## ADDENDUM NO. TWO (2)

Date: 03/28/2022 Architect's Project No. A20-159

Project: IFB 22-003 Sugar Hill Historic Cemetery

Client: City of Sugar Hill

C2.2

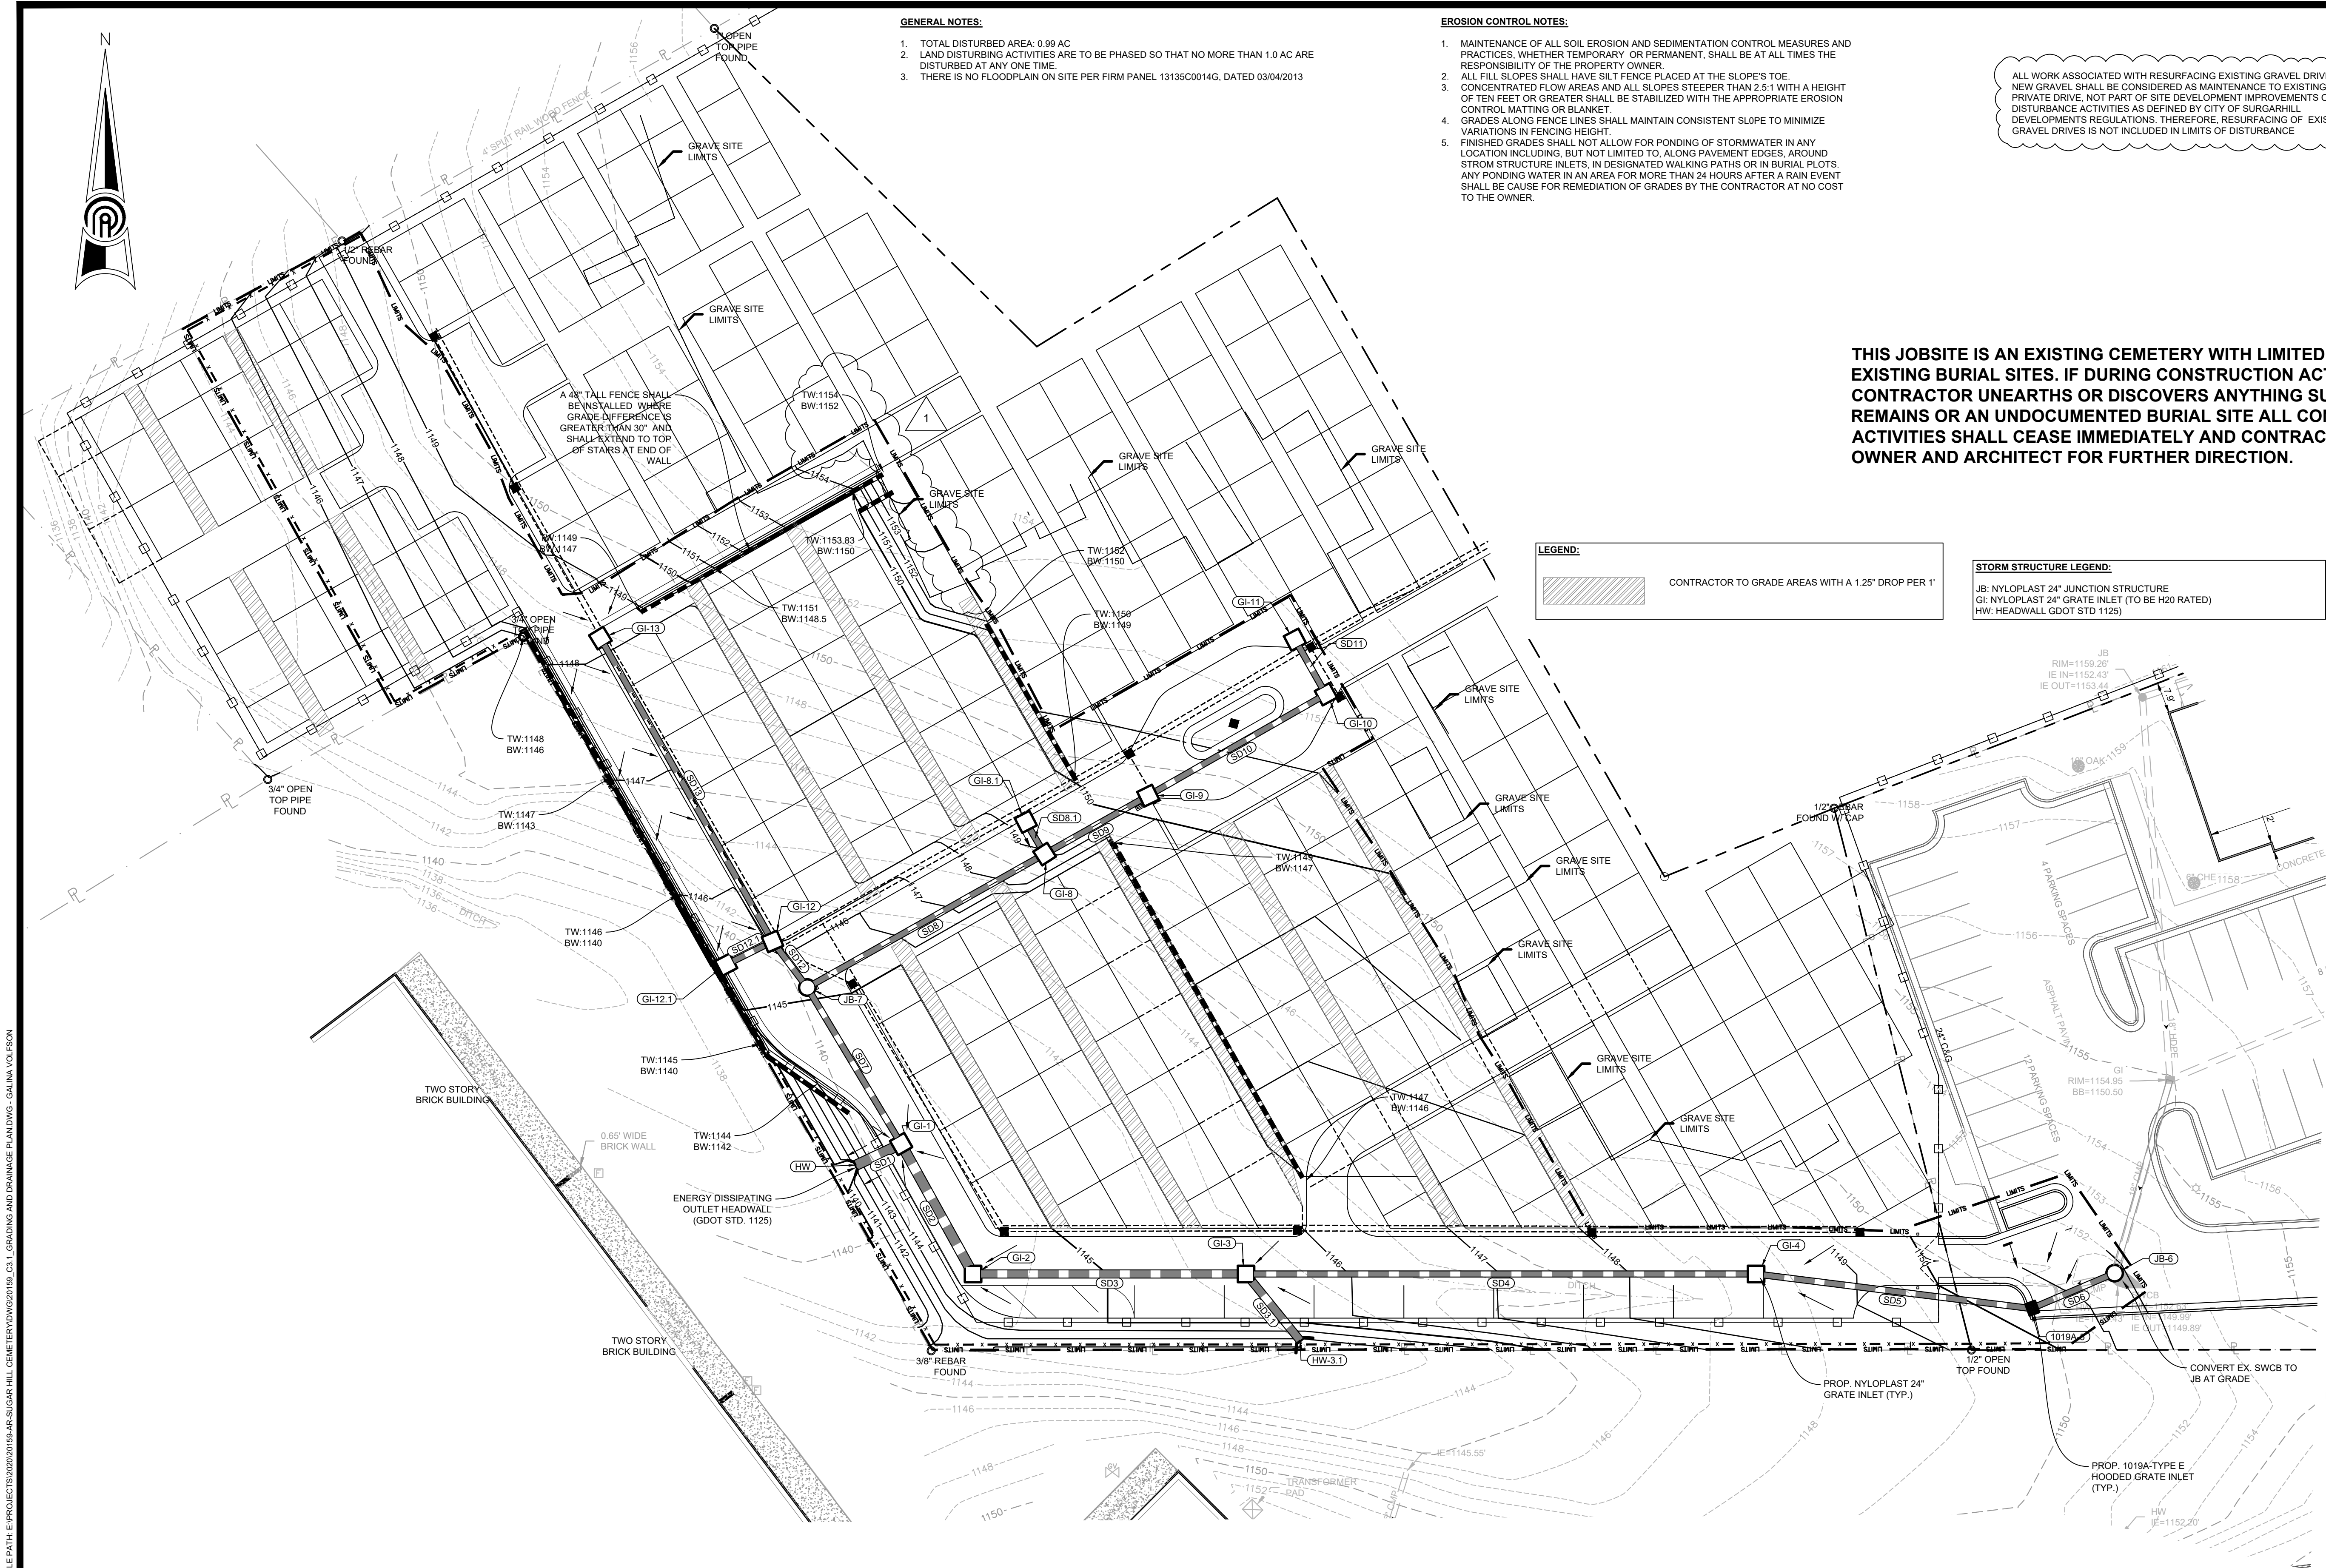
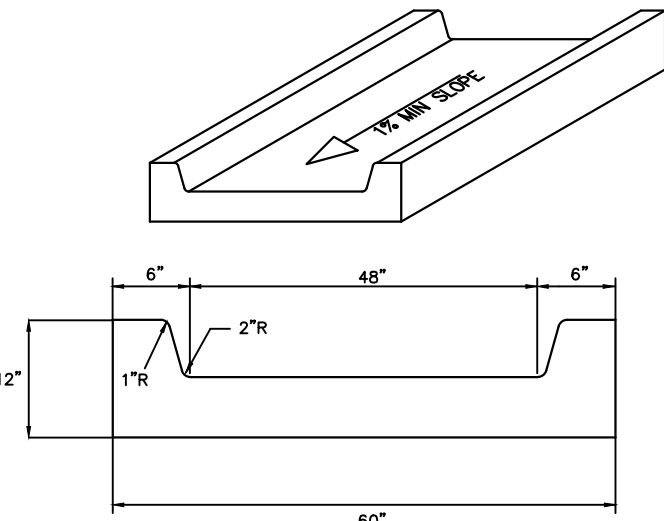
4. Refer to concrete flume detail on sheet C2.2.
5. Construction entrance shall be provided coming into the new grading limits from the Church Street Entrance where the existing cemetery plots stop. Refer to revised sheet C5.1.
